SEWAGE DISPOSAL TESTING

MARYLAND STATE DEPARTMENT OF HEALTH

SUBDIVISION Ridgeways LOT NO. 5ROAD AND DESCRIPTION Underwood Rd. (see original application for better directions)

PLOT PLAN

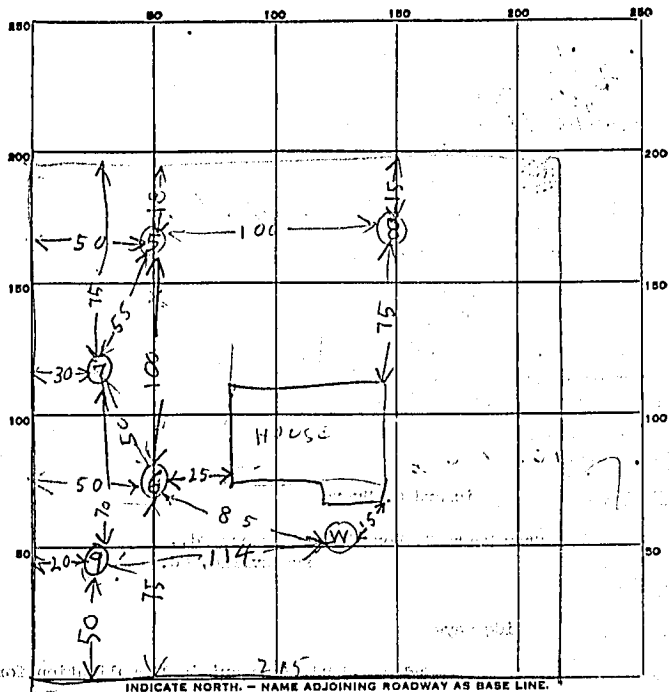
5/15/71
9:30
Deep tile field - 750 sq ft bottom area
9:30 installed 6 FT to 9 FT below grade

Place tile field in area 10 FT to 40 ft from the left side of the lot as seen when facing the lot
TO: THE COUNTY HEALTH OFFICER
ELLCOTT CITY, MARYLAND *from Underwood Rd and between lot line*

I, HEREBY, APPLY FOR THE NECESSARY TESTS IN ORDER TO CONSTRUCT (OR RECONSTRUCT) A SEWAGE DISPOSAL SYSTEM. *10 FT and 145 FT from the back*
